# **General Equipment Safety Bulletin**

Reference Number	Bulletin 01 - 2016
Affected Product	D11T Tractors with AMA / MDG serial number prefix, fitted with the latest version of the optional high pressure hydraulic screen group
Risks Identified	Failure of the 421-7245 Hose assembly may result in a machine fire
Revision	First release

# Chafing and Failure of 421-7245 Hydraulic Hose

Figure 3. Hydraulic screen mounting bolt locations. NB: ladder clips (locations L, M, N) require longer 4L6454 bolts.

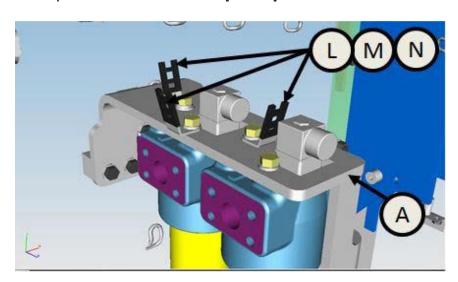
There have been known cases where the six bolts that attach the two hydraulic screens to their mounting bracket have been found to be loose, missing, or the threads stripped. This has resulted in the subject hose having additional unintended movement.

- 3. Inspect the security of the hydraulic screens to the 421-7250 mounting bracket. There should be six bolts securing the two screens to the mounting bracket. Three mounting bolt locations have a ladder clip and require a 4L-6454 bolt [3/8" x 1" long], and the other three locations require a 5S-7379 bolt [3/8" x 7/8" long] refer to Special instruction REHS8552-02 for details. If a shorter bolt has been incorrectly fitted where a longer bolt is required, the thread in the screen may be damaged. Inspect each bolt for correct length, and correct any defects, and torque the six bolts to 47 Nm [35 ft lb].
